Release Notification

Remediation Plan

**RE: Remediation Work Plan Addendum
Ross Draw Unit #034
Incident Numbers nAPP2107554265, nAB1736055339 (2RP-4529) and nAB1528240224
(2RP-3322)
Eddy County, New Mexico**

Figure 1 Site Location Map
Attachment 1 Referenced Well Records

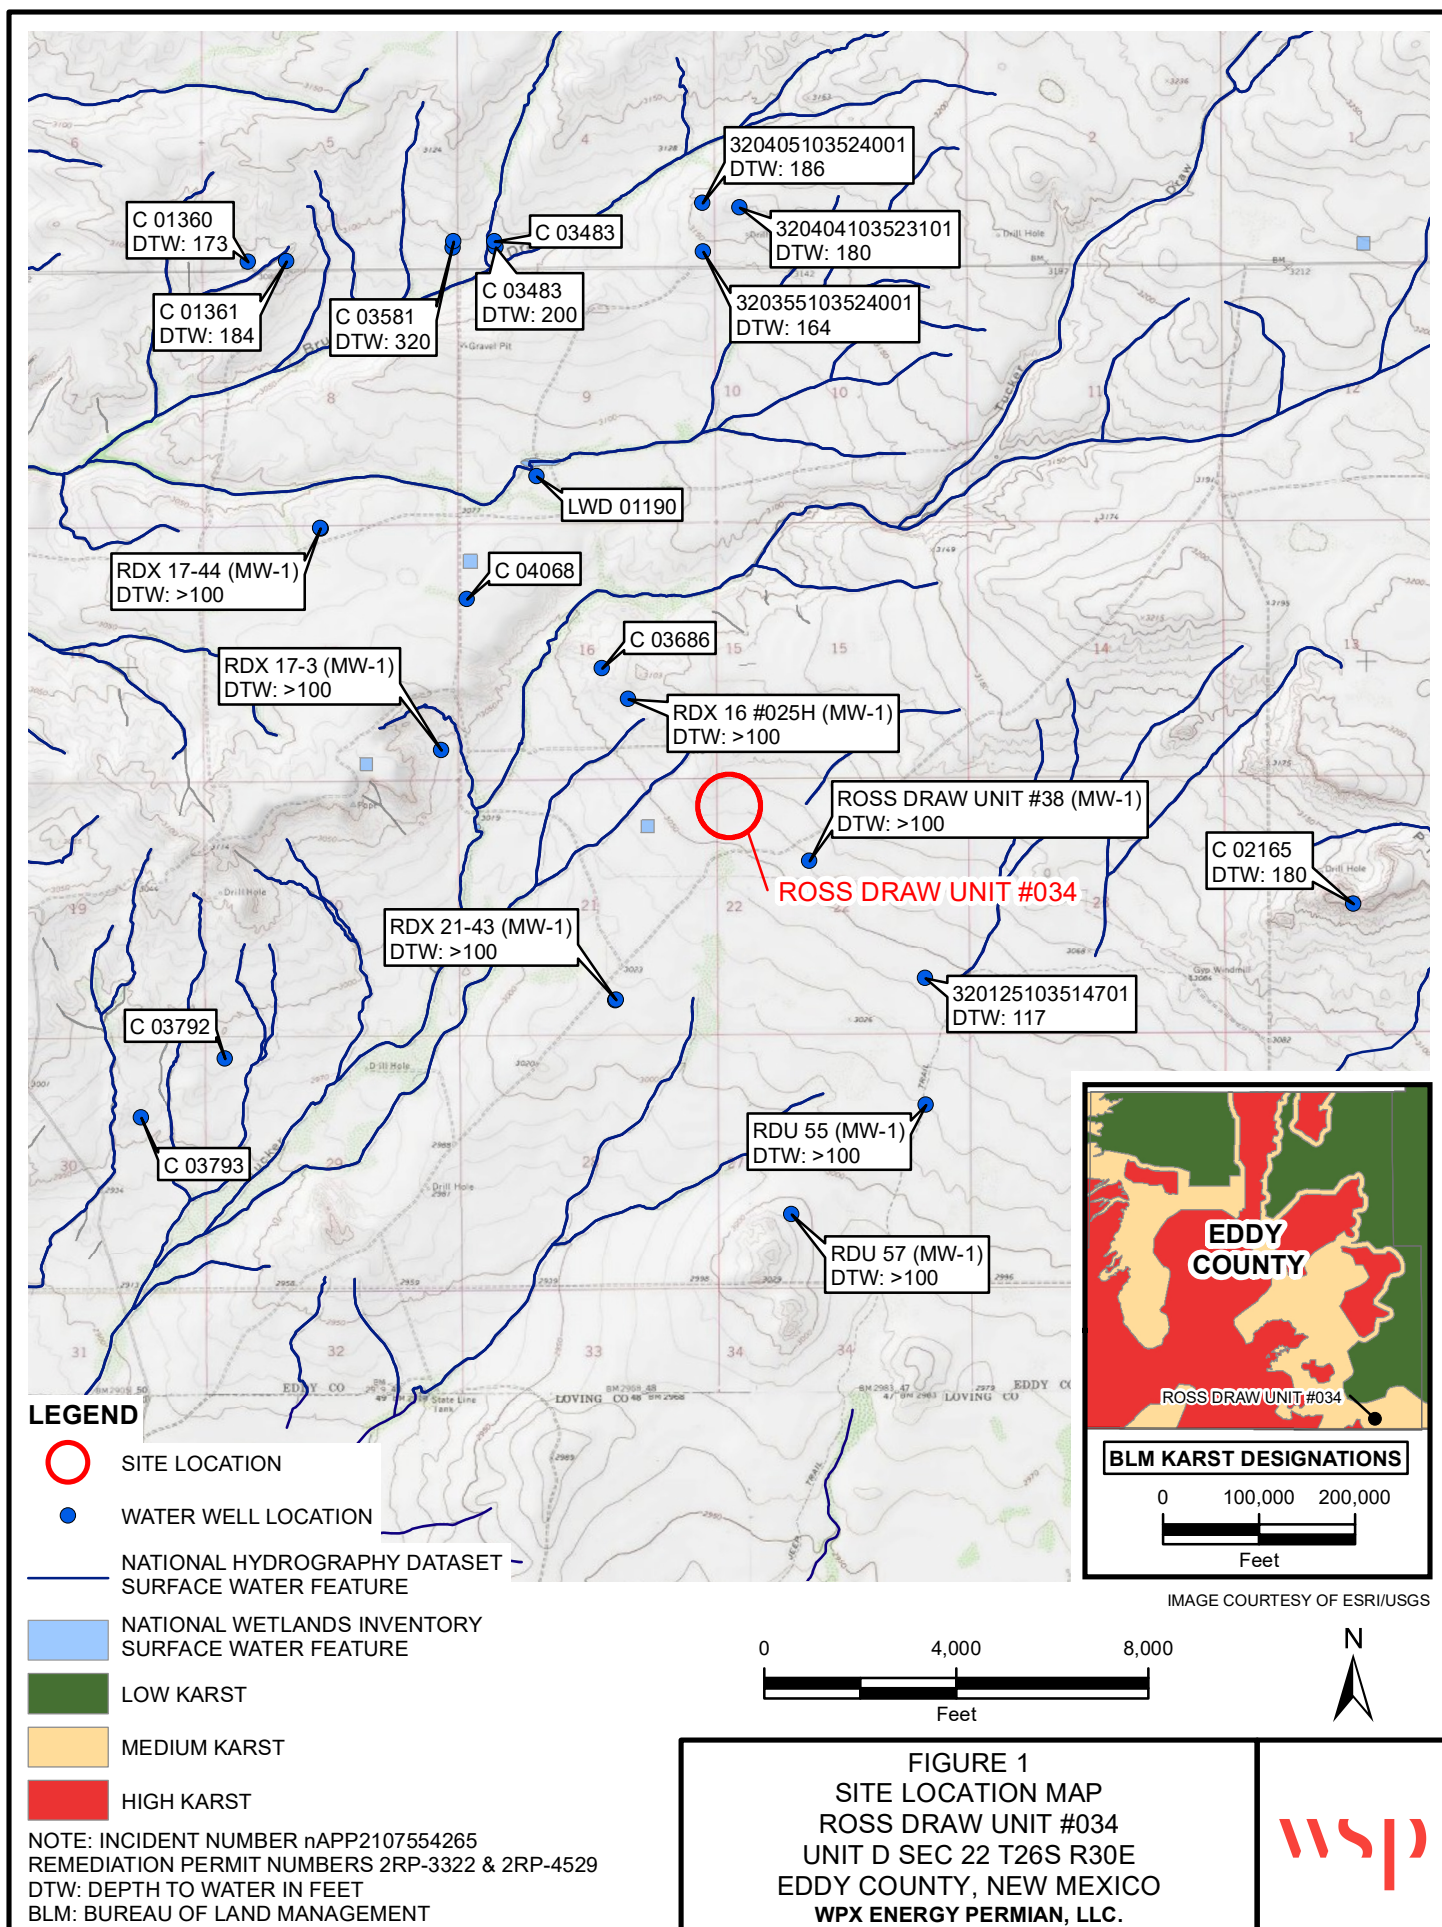
- *When nearby wells are used to determine depth to groundwater, the wells should be no further than ½ mile away from the site, and data should be no more than 25 years old, and well construction information should be provided. If evidence of depth to ground water within a ½ mile radius of the site cannot be provided, impacted soils will need to*

meet Table 1 Closure Criteria for ground water at a depth of 50 feet or less. The Closure Report is denied due to inadequate and unapproved sampling plan.

As indicated in the original Remediation Work Plan Request, depth to groundwater at the Site is estimated to be greater than 100 feet bgs based on soil boring MW-1, associated with Ross Draw Unit (RDU) #38, that was drilled by Talon LPE on December 8, 2020. The soil boring is located approximately 0.36 miles southeast of the Site (32.030491°, -103.871260°). Using a truck mounted drill rig equipped with hollow stem auger, the soil boring was advanced to a total depth of approximately 105 feet bgs. Groundwater was not observed within the soil boring after at least 72 hours. Following the observation period, the boring was plugged and abandoned. The boring log is included as Attachment 1.

In addition, WPX installed six other borings in December 2020 (RDX 16 #25H (MW-1), RDX 21-43 (MW-1), RDX 17-3 (MW-1), RDX 17-44 (MW-1), RDU 55 (MW-1), and RDU 57 (MW-1)) within a 3-mile radius of the Site and depth to water results for all six indicated groundwater was not encountered within 105 feet of the ground surface. Two other water wells, United States Geological Survey (USGS) well number 320125103514701 and New Mexico Office of the State Engineer (OSE) well number C 02165, indicate depth to water was 117 feet bgs and 180 feet bgs, respectively. Regionally, depth to water appears to be greater than 100 feet bgs and therefore the depth to water estimate for RDU #38 appears to be consistent with the regional data, thus a representative water well for estimating depth to water for the Site. Figure 1 depicts the nine water wells described above.

Depth to Water Criteria	Response – Water Well RDU #58 (MW-01)
Well located within ½-mile of the Site	Approximately 0.36 miles from the Site
Depth to water measurement within the last 25 years	Well drilled and depth to water measured in December 2020
Well Construction Provided	The boring log and well construction information was provided in the original Remediation Work Plan Request and included in Attachment 1 of this Addendum
